Agenda Item 4: Committee Report – Giant’s Burn Windfarm

Planning and Access Committee

SUBMITTED BY:	Director of Place
APPLICATION NUMBER:	ECU00005007 (Scottish Government Energy Consents Unit reference) EXT/2025/0011
APPLICANT:	GB Wind Farm Ltd.
LOCATION:	Giant’s Burn Windfarm, Dunoon
PROPOSAL:	Proposed windfarm comprising of up to 7 wind turbines, of which up to 5 are 200m to tip and up to 2 are 180m to tip, with BESS and associated infrastructure
NATIONAL PARK WARD:	N/A
COMMUNITY COUNCIL AREA	Kilmun CC, Dunoon CC and Sandbank CC
CASE OFFICER:	Name: Jennifer Paton Tel:01389727738 E-mail: jennifer.paton@lochlomond-trossachs.org

Appendix 1 – Zone of Theoretical Visibility

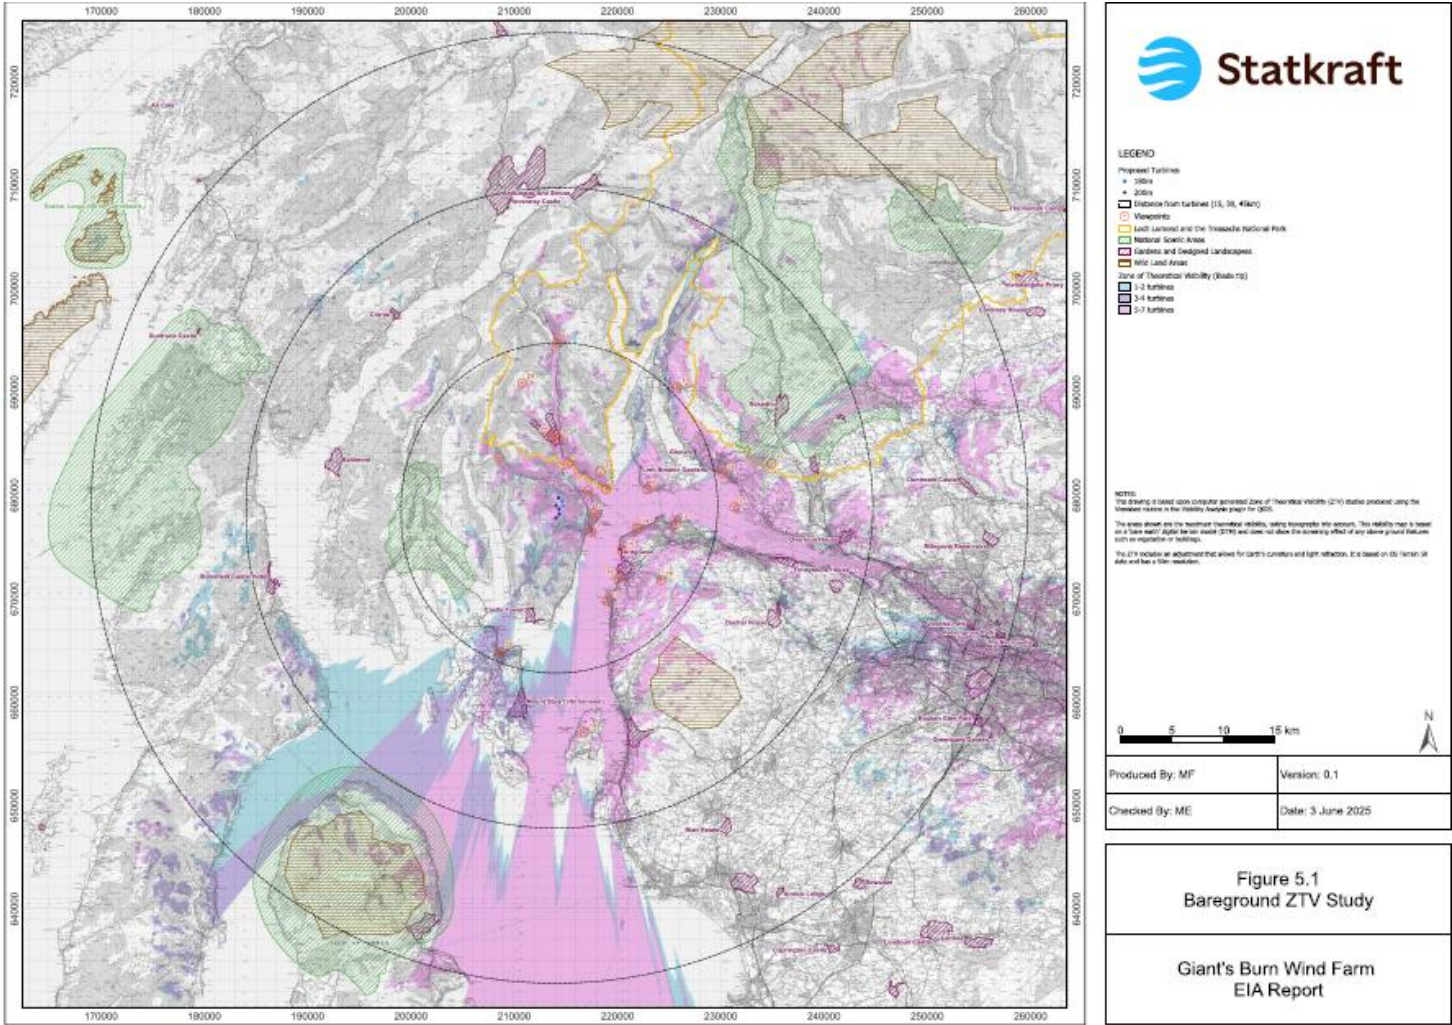
- 6.11. The LVIA ZTV ‘EIAR figure 5.1’ (Appendix 1 of this Report) identifies the theoretical visibility of the proposed windfarm development within the National Park across areas of the Argyll Forest including the southern coast at the Holy Loch, Strone and Kilmun, from lower elevations within Kilmun Arboretum, Benmore Botanic Gardens, the River Eachiag valley, across the majority of Loch Eck and from elevated valley sides and summits including Strone Hill, Bienn Mhor and Ben Bhula.

- 6.12. The ZTV at Appendix 1 is a ‘bare-ground’ ZTV which is based on landform and does not account for the screening effect of buildings or forestry (thereby representing worst-case/ maximum visibility). However, for other ZTVs within the LVIA (applicant’s figures 5.2, 5.5, 5.6 and 5.8) buildings have been assigned an assumed height of 7m and forest 15m (based on OS data). These give an impression of reduced visibility. This is not declared on the ZTV figures. Forestry is widespread in the area and felling coups a common feature. The consented Overhead Line from Dunoon to Loch Long and Larch removal will increase the extent of visibility of the development. Widely available recent aerial photography indicates some of the areas shown as woodland on the OS Open Map Local have already been felled in proximity to the proposal, rendering much of the visibility mapping supporting the LVIA out of date. Therefore, LVIA ZTV figures including 5.2, 5.5, 5.6 and 5.8 do not represent a worst-case scenario and do not accord with GVIA best practice guidelines.

Blairmore and Ardentinnny. The ZTV Fig 5.1 (Appendix 1 of this report) indicates visibility of all 7 turbines from this route and at a distance of 4km away from the windfarm the turbines will be open, close-range views.

Figure 7 View Point 6: Ben More Garden – Entrance

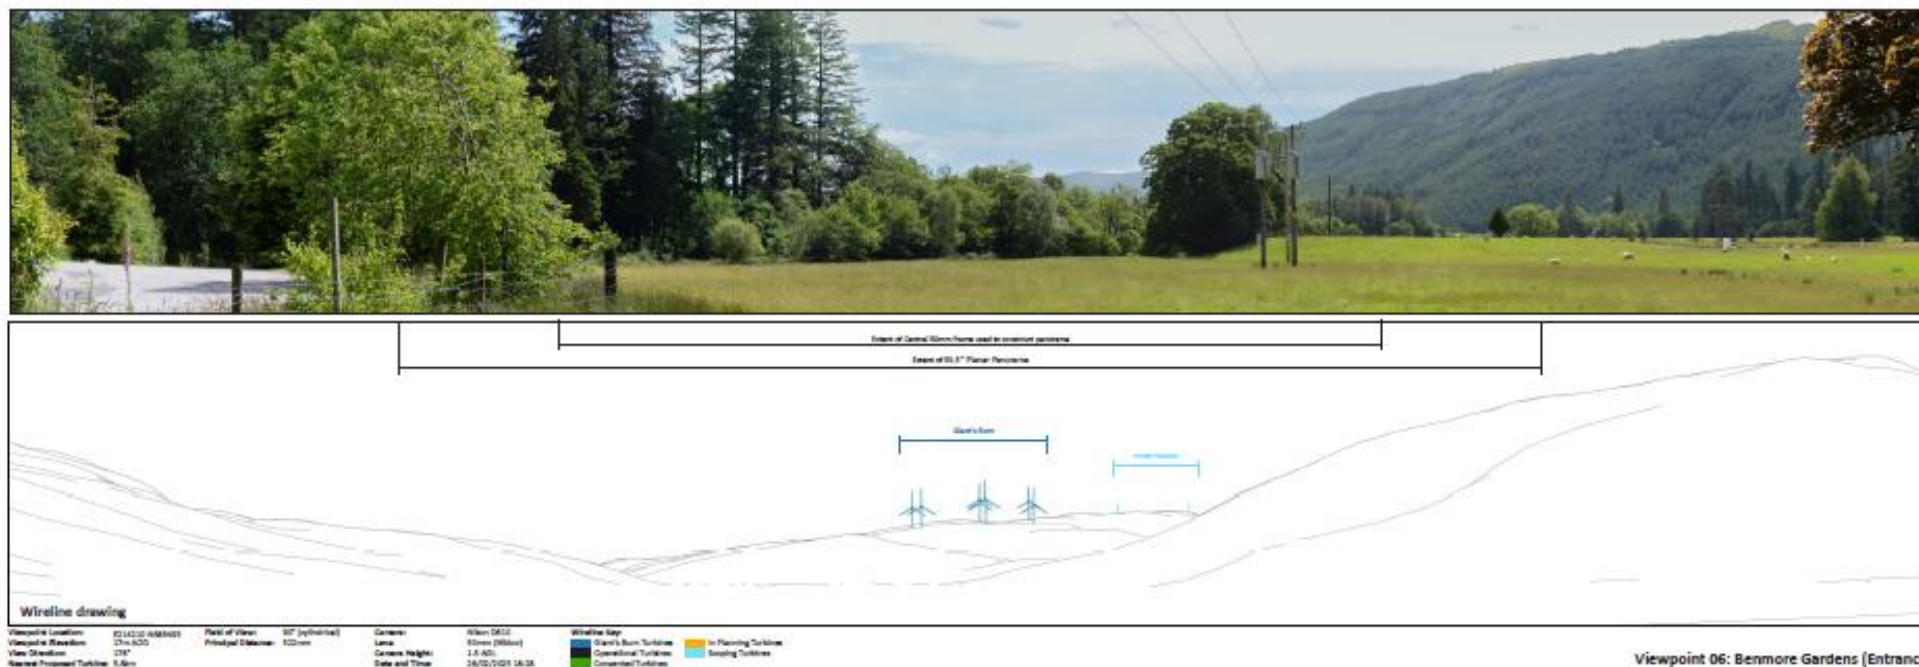
- Kilmun, this includes Kilmun Arboretum. The effects are illustrated Viewpoint 5 A815 'Orchard' (**Figure 6** at Appendix 2 of this report) and illustrative view J (**Figure 13** at Appendix 2). The National Park agrees with this assessment.
- Strone. The effects are illustrated Viewpoint 4 Strone Pier (**Figure 5** at Appendix 2) and illustrative view J (**Figure 13** at Appendix 2). The National Park agrees with this assessment.
- Local roads and core paths between Sandbank and Loch Eck. The effects are illustrated in Viewpoint 6 (**Figure 7** at Appendix 2). The National Park agrees with this assessment.

- Viewpoint 8: Dornoch Point / A815 receptor group (Figure 7)
- Viewpoint 23: Strone Hill (**Figure 11**)
- Viewpoint 24: Beinn Mhor (**Figure 12**)
- Viewpoint 6: Benmore Gardens Entrance (**Figure 7**) and
- Viewpoint 22: Benmore Gardens Hilltop (**Figure 10**)

Figure 10 View Point 22: Benmore Garden (Hilltop Viewpoint)

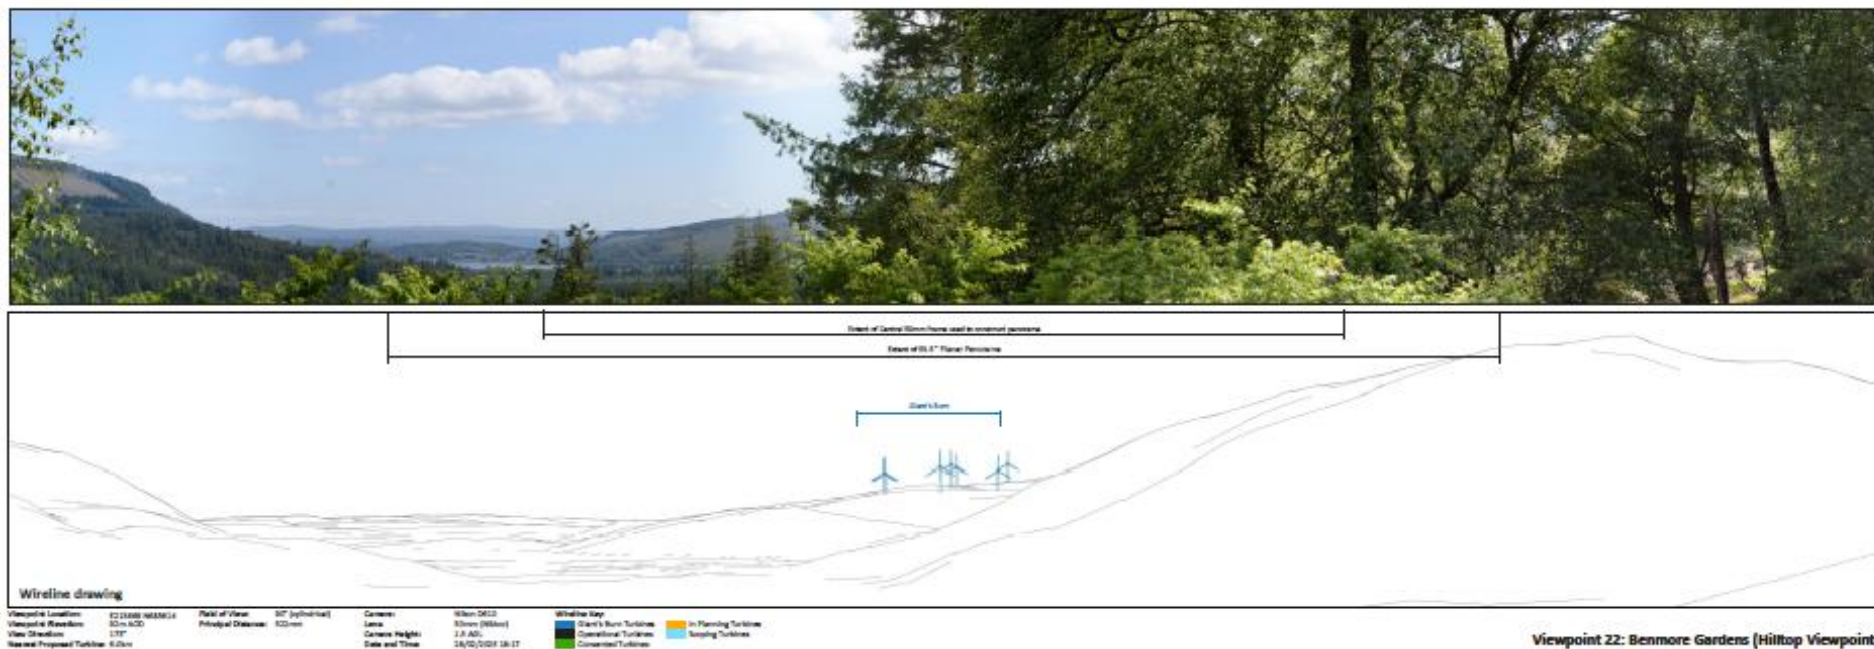
6.39. In terms of the visual effects experienced from Benmore Gardens, the LVIA recognises that the Wind Farm development '*would be more openly seen walking back down the steps and from some of the paths below the viewpoint in the upper parts of the garden.*' Also noted by the LVIA the 2025 storm caused '*notable damage to the gardens which may mean there are more open views from higher areas of the garden in the medium to long term*'

6.40. The National Park considers that given these recent storm events have resulted in loss of vegetation (but also seasonal changes in the autumn / winter and possible future disease control) there would be opportunity to experience views of the proposed development beyond those represented by Viewpoint 6: Benmore Gardens (Entrance) (**Figure 7** Appendix 2) and Viewpoint 22 - Benmore Gardens (Hilltop Viewpoint) (**Figure 10** Appendix 2). It is considered that there would be significant visual effects experienced from within Benmore Botanic Gardens particularly near Benmore House (cultural viewpoint 16 – wireline drawing) (**Figure 16** at Appendix 2) and from higher elevations including the ascent / descent to the Wright Smith Memorial Viewpoint and Shelter. We therefore disagree with the applicant that no significant visual effects would be experienced by visitors to the Benmore Botanic Gardens.

Figure 15 Illustrative viewpoint L – Gourock-Sandbank Ferry

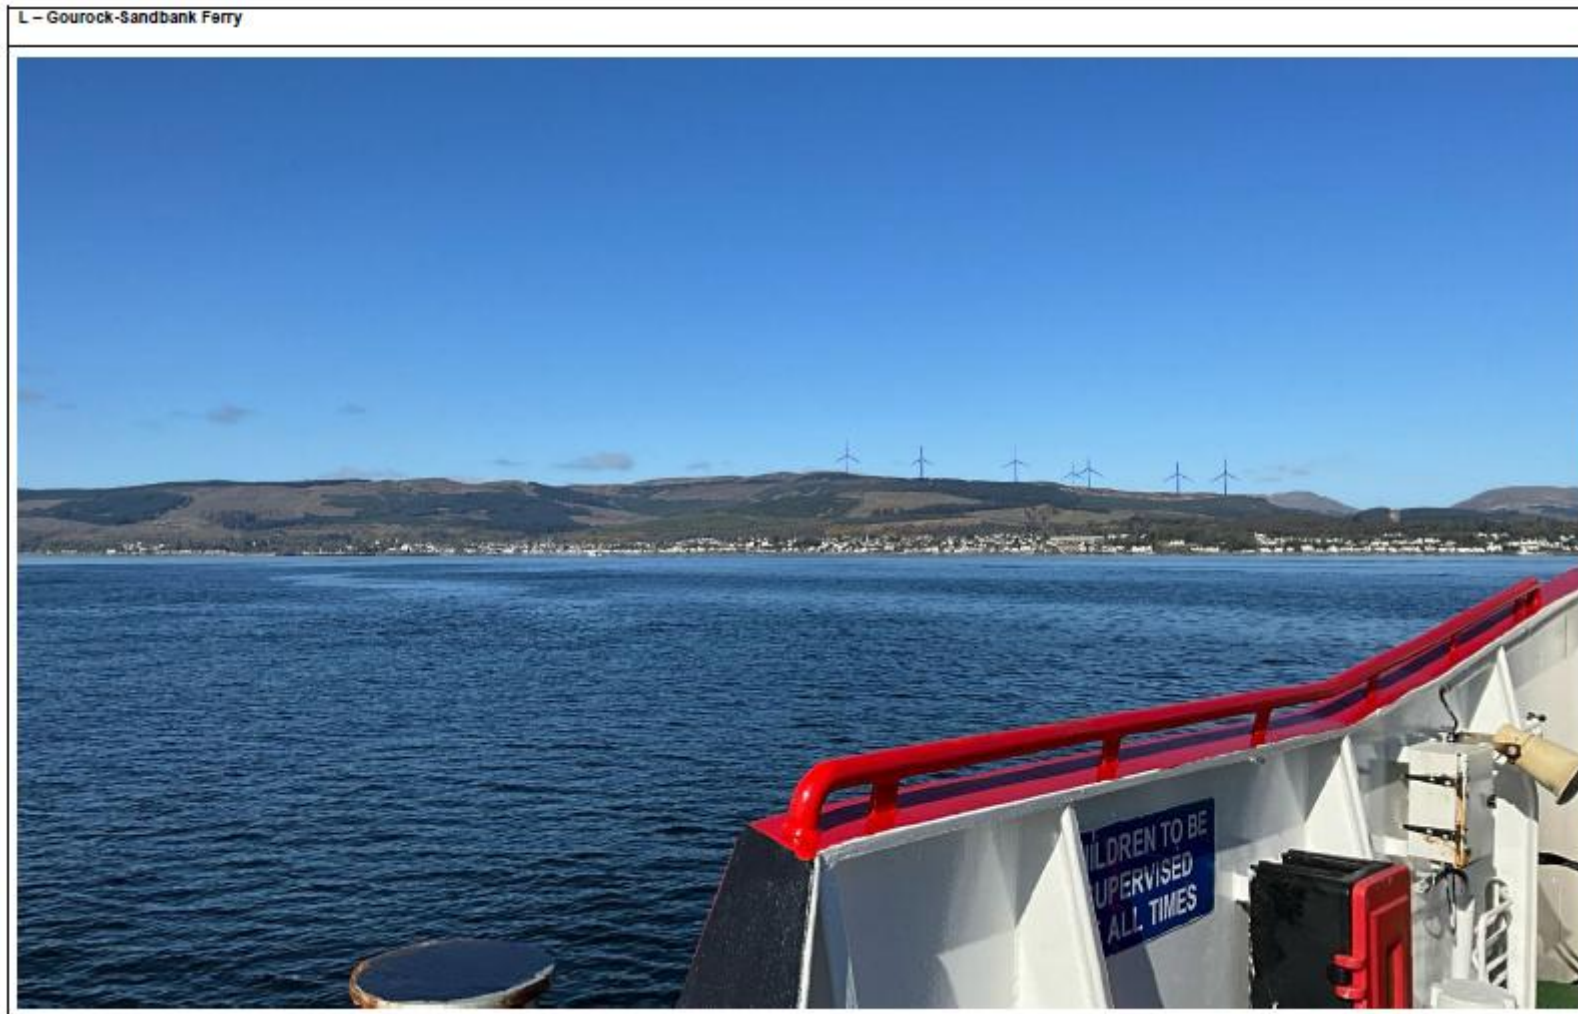
- 6.28. It is stated in the description for SLQ 9 that: *"The high mountains and long sea lochs restrict access by road into the area, so that travel by sea has always been the easiest, preferred means of travel. This continues today with the ferries across the Firth of Clyde providing access into Holy Loch, Loch Goil and the lower reaches of Loch Long"*. Although it should be noted that this description provides narrative for the Firth of Clyde outside the National Park, the site forms part of the wider skyline experienced when journeying by ferry from the more heavily settled southern side of the Clyde. A sense of journey to the remote is experienced crossing the Firth of Clyde toward the coastal gateway of the National Park, an experience that would be adversely affected by the introduction of the proposed development onto the undeveloped skyline in northward looking views as shown by Illustrative View L – Gourrock-Sandbank Ferry (**Figure 15** Appendix 2).
